April 27, 1995

Subject: Response to Request for Additional Information
(RAI) Pertaining to the Proposed Technical
Specification Amendment for the Nominal PORV
Pressure Relief Setpoint Versus RCS Temperature
for the Cold Overpressure Protection System

Subject: Technical Position on Random Instrument Uncertainty for P-T Limits and COMS Setpoints.

FIG. G-2210-1

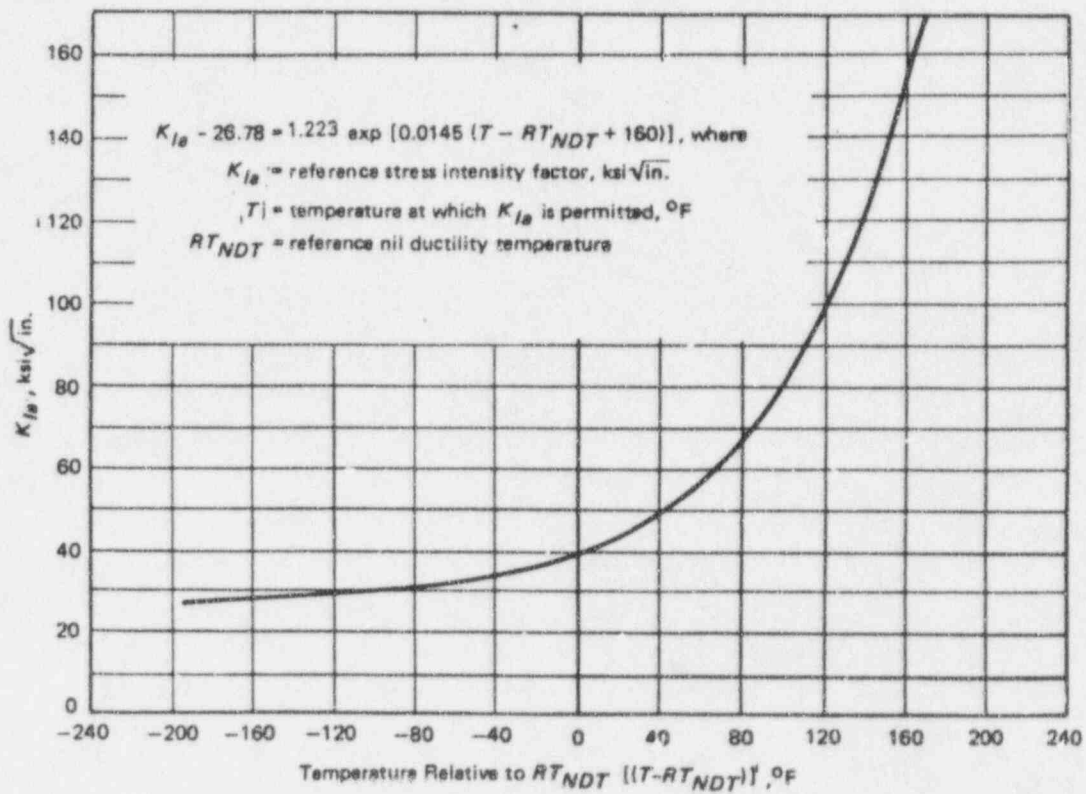
- 2) ASME Section XI Appendix G allows the sum of the pressure stress intensity factor (multiplied by a safety factor of two) and the thermal stress intensity factor to be no higher than the reference stress intensity factor K_{IC} shown in Appendix G Figure G-2210-1 (attached). The K_{IC} value at a given temperature is the lower bound of all available static, dynamic, and crack arrest fracture toughness data, and is identical to the lower bound crack arrest K_{IC} values shown in Section XI Appendix A Figure A-4200-1 (attached). This is considerably more conservative than either the crack initiation toughness, K_{IC} of Appendix A Figure A-4200-1 (which Section XI Appendix E permits for evaluating the effects of actual overpressure events on the operability of an RPV), or the actual fracture toughness of the RPV limiting material, which would be expected to fall above the K_{IC} curve.

FIG. 5—Reactor vessel cool-down limit curves. $\Delta T/\Delta t$, maximum 33°C/h (60°F/h) [1 psig = 6.9 kPa; 1 in. = 25.4 mm; $^\circ\text{C} = (^\circ\text{F} - 32)/1.8$].

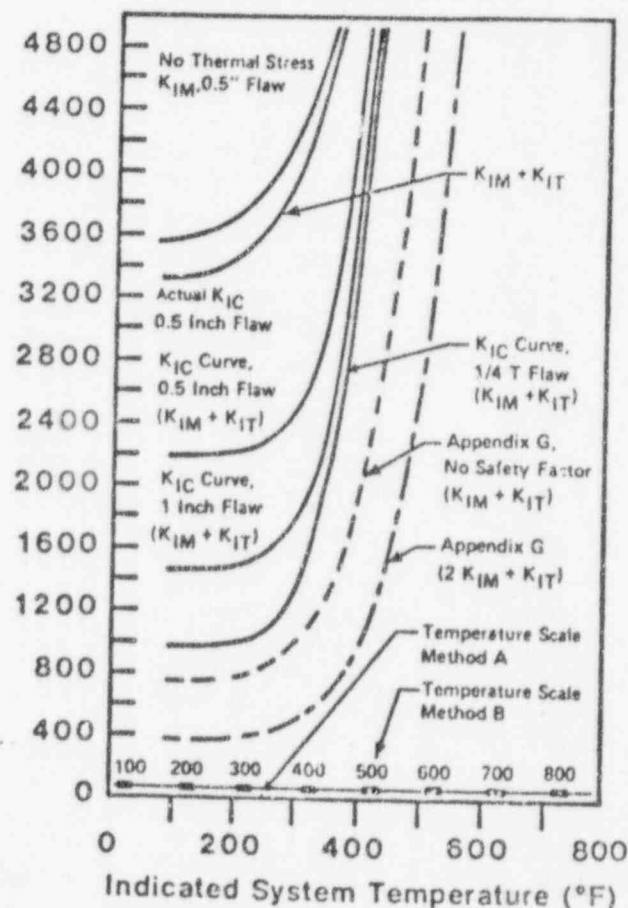
Figure 5 of the Reference (attached) illustrates the conservatism typical of P-T limits developed in accordance with Appendix G for a typical PWR at an end-of-life fluence.

At the lower end of the operating temperature range, where the concern for protection against nonductile fracture is highest, Figure 5 shows that a margin of at least 600 PSIG exists above the Appendix G P-T limit if the sum of the actual pressure and thermal stress intensity factors is not allowed to exceed the K_{IC} curve.
